MEMORANDUM

DATE: FEBRUARY 14, 2025
REVISED: MARCH 4, 2025
TO: VINCENT DUQUETTE
FROM: MICHAEL PETEPIECE / KALLIE AULD
RE: GREYSTONE VILLAGE
 PCSWMM MODEL UPDATES FOR PHASE 3
 NOVATECH PROJECT # 114025
CC: ABDUL MOTTALIB, CITY OF OTTAWA

CITY OF OTTAWA
375 DESCHATELETS AVENUE
GREYSTONE VILLAGE PHASE 3
DRAWING NAME: STORMWATER MANAGEMENT PLAN
PROJECT No.: 114025-PH3
REV #10
DRAWING No.: 114025-STM(PH3)
#17640

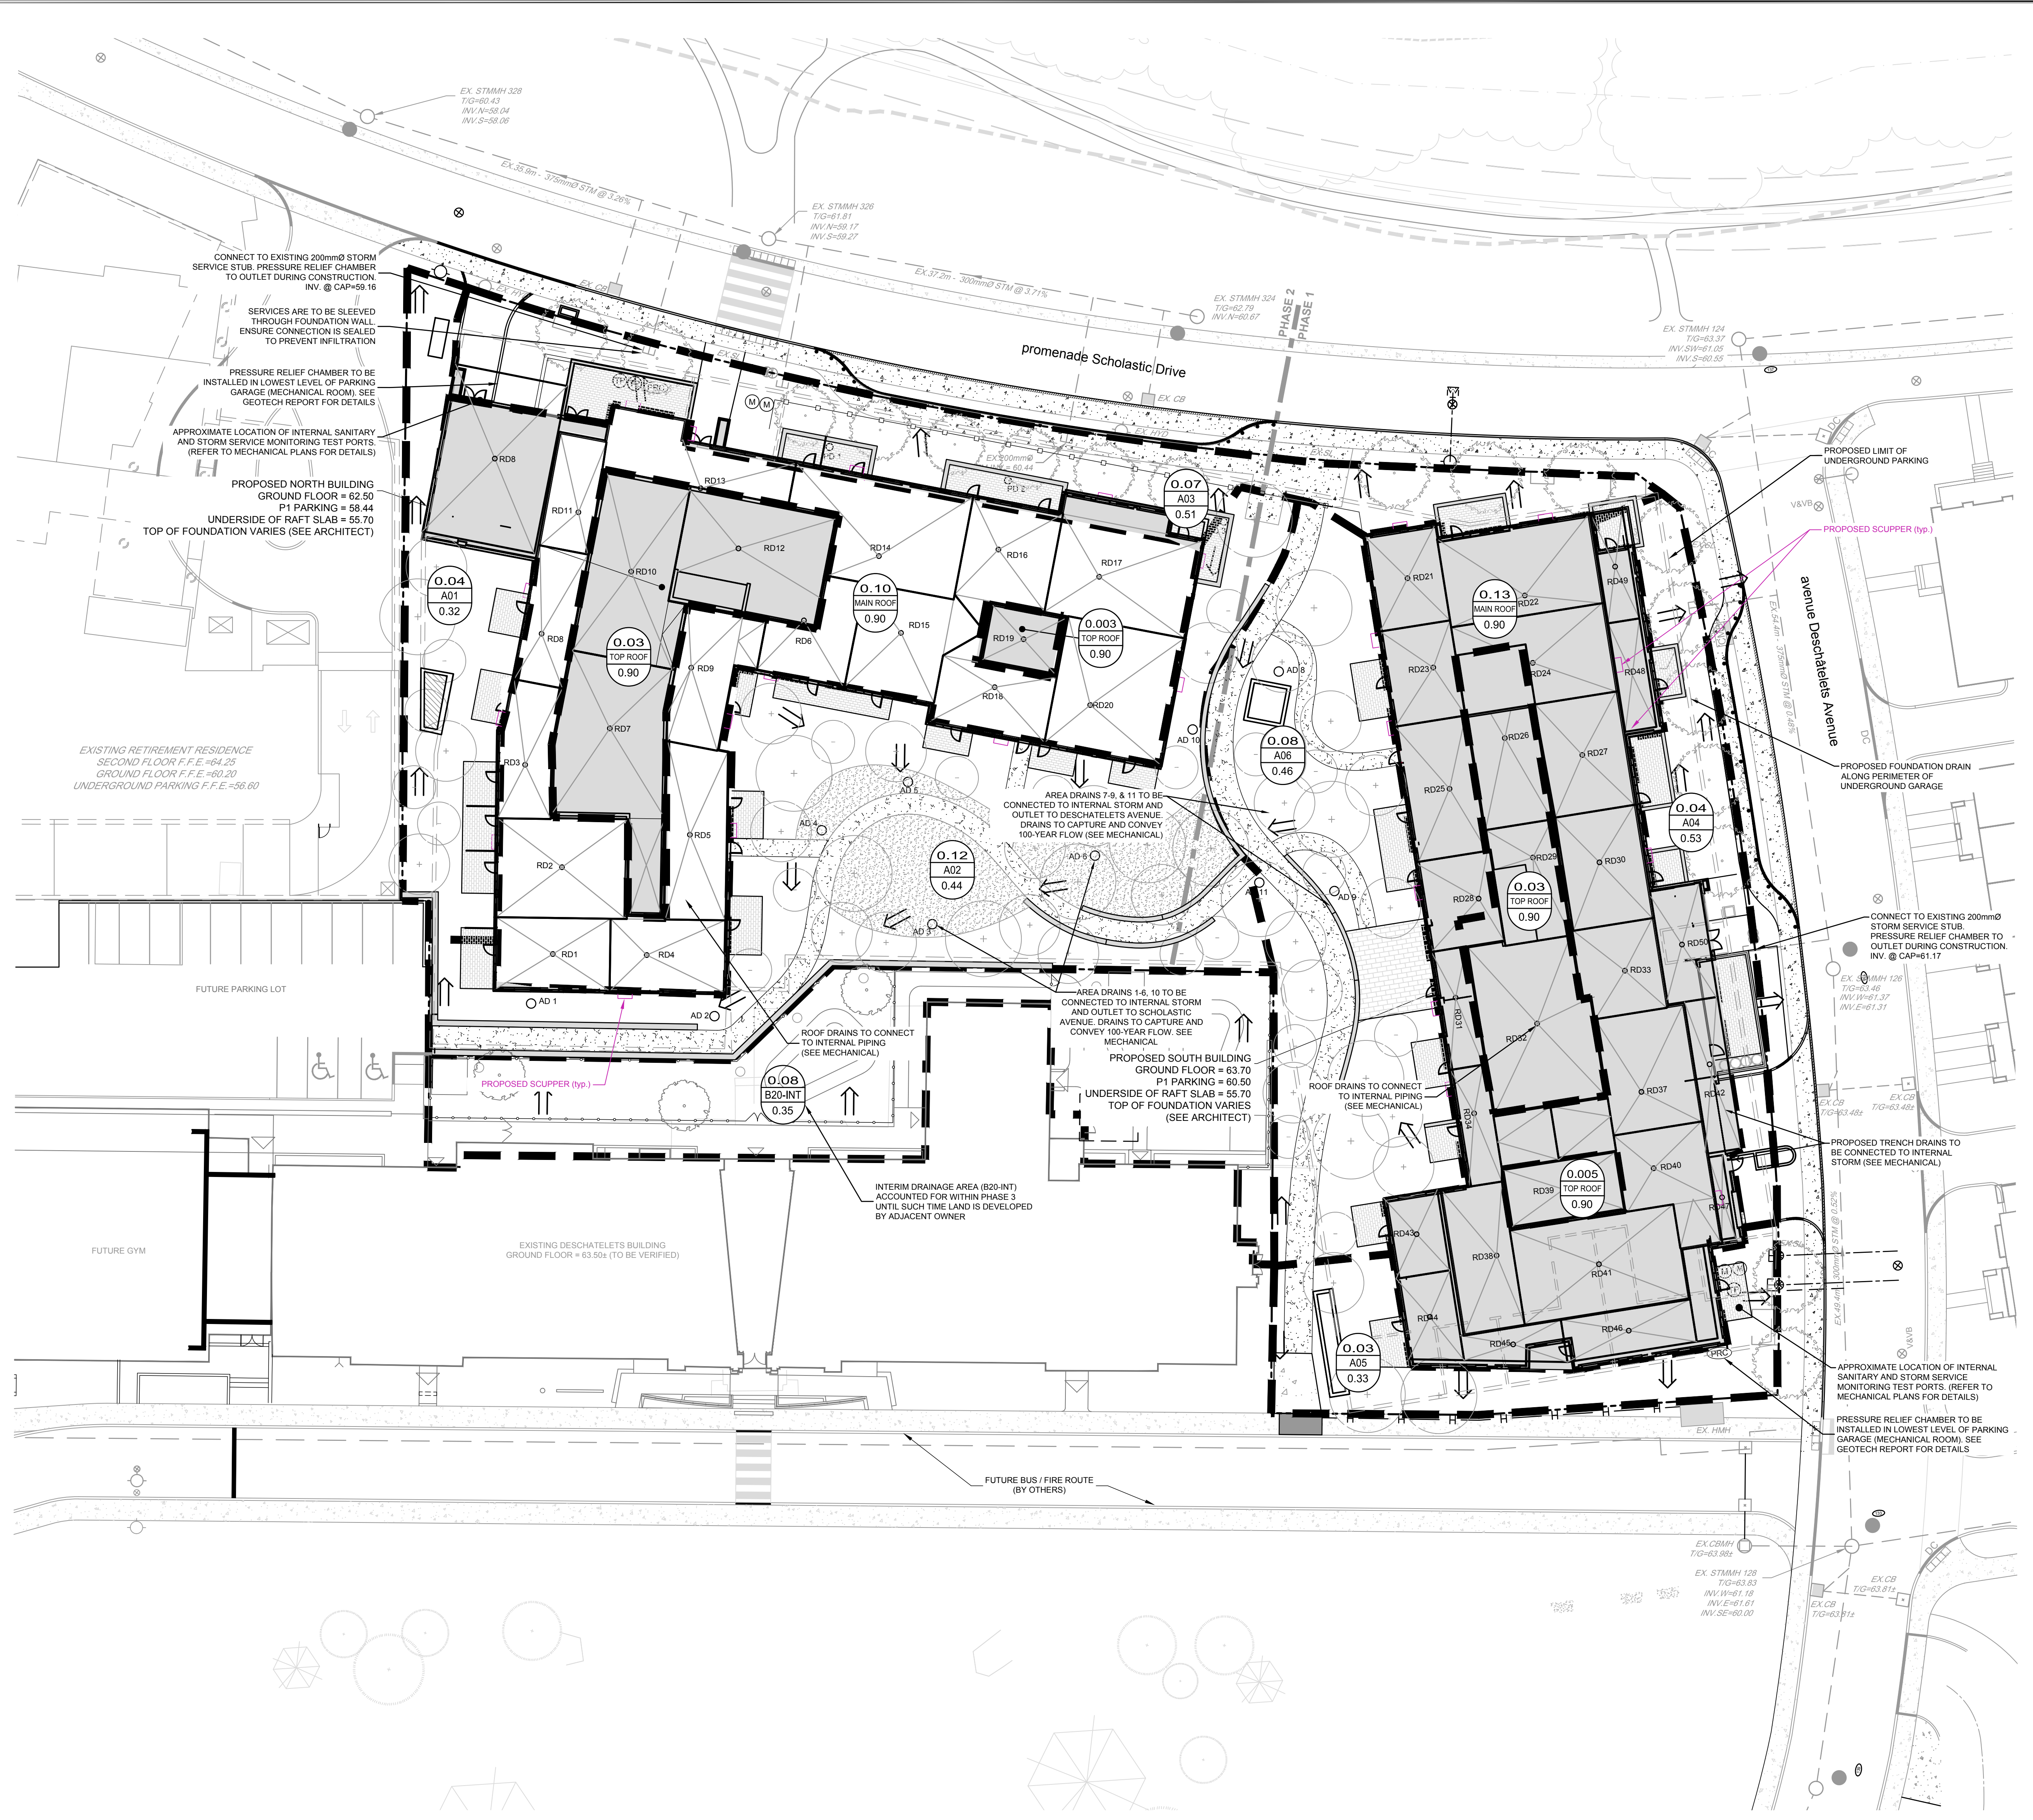
The roof design has been revised and the PCSWMM model has been updated to reflect the new controlled roof drain flows from the south building (Area 21A). The revised flows are slightly higher than the previous model but the increase is not significant with respect to the capacity of the receiving sewer on Deschatelets Avenue.

Area 21A (South Building Roof)	Peak Flow (L/s)	
	5-year	100-year
Old Roof Flows	8.25	10.49
New Roof Flows	9.80	13.08

In the previously approved PCSWMM model (January 17, 2025), the storm service from the Phase 3 south building (Area 21A) was connected to the storm sewer on Deschatelets Avenue at MH126. The model has been updated to more accurately show the service connection location between MH128 and MH126 by adding a new node to the model (J21).
